Bridge Standards Update

Matthew Pooler | Bridge Preliminary Plans Unit

May 17, 2017

Minnesota Department of Transportation – Bridge Office REVISION LOG for B905

B905 **Fence Post Anchorage**

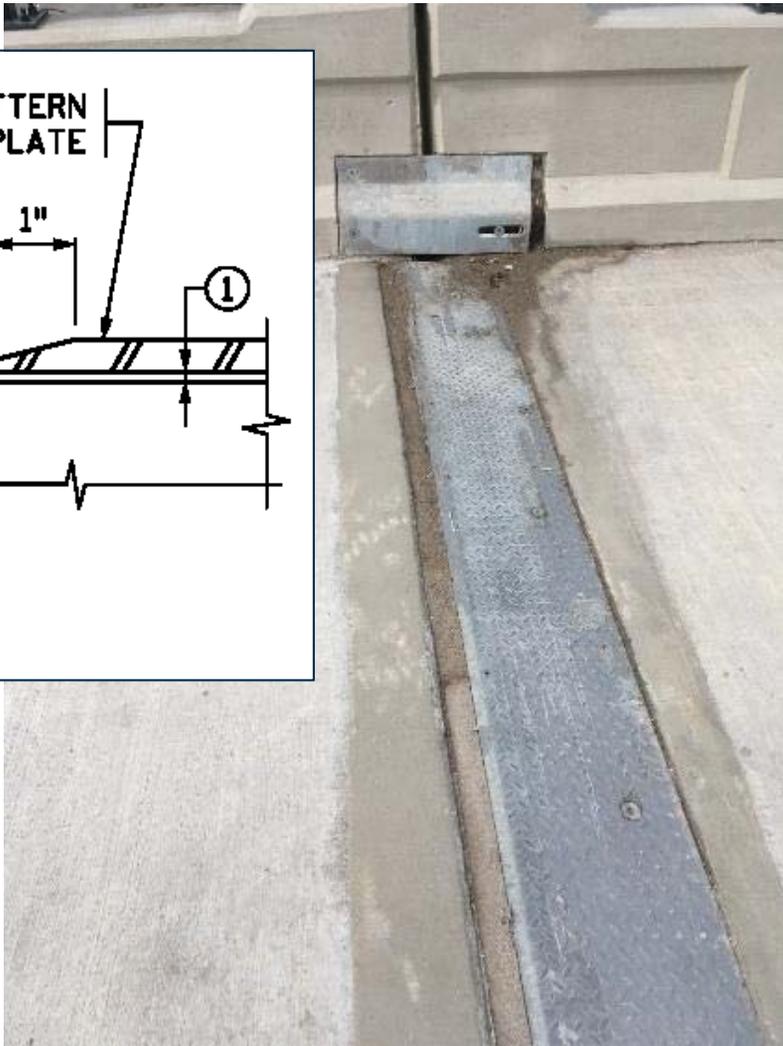
REMOVED From The B-DETAIL:

- Plan View-Type B, Plan View-Type C and the Grout Alternate details.

Under NOTES:

- Added first note: “All pipe diameters are nominal”.
- Added second note: “See special provisions for requirements not included on this sheet”.
- Added 6th note: “Furnishing and installing fence post anchorages is incidental to the wire fence”.

- Removed “Mn/DOT” from the second, third and fourth notes.
- Added numbered note ①: “Adhesive anchorage with 3/4" dia. anchor rod per spec. 3385, type a with hex nut and washer. Provide an adhesive with a minimum characteristic bond strength in uncracked concrete of 1.5 ksi. Embed the anchorage no less than 5" regardless of characteristic bond strength. Drill through reinforcement (if encountered) to achieve minimum embedment. Ensure hex nut is in contact with the adjacent surface and torque to 60 ft-lbs unless a higher torque is recommended by the manufacturer. Proof load to 7.5 kips. See special provisions for additional requirements.”

- Added numbered note ②: “E70X electrodes for 3/8" post to base plate weld”.
- Under the Double Extra Strong Pipe Weights: Removed the 1½" nominal diameter note.

At TYPICAL SECTION:

- Changed the base plate thickness from ½" to ¾". Removed the dimension and labeled base plate as ¾".
- Changed the Anchorage projection above the concrete surface from 2" to 2¼".
- Changed the weld size from 1/4" to 3/8" and added numbered note ②.
- Changed the anchorage note to: “Approved Adhesive Anchorage ①”.
- Changed the caulk and shim note to: “Caulk and shim base plate per special provisions”.

At PLAN VIEW – TYPE A:

- Added (TYP.) to the 4" dimension and added additional 1½" dimensions to the hole locations.
- Changed the pipe sleeve note to: “Pipe sleeve for intermediate posts and end posts use 2" nominal dia. double extra strong pipe”.
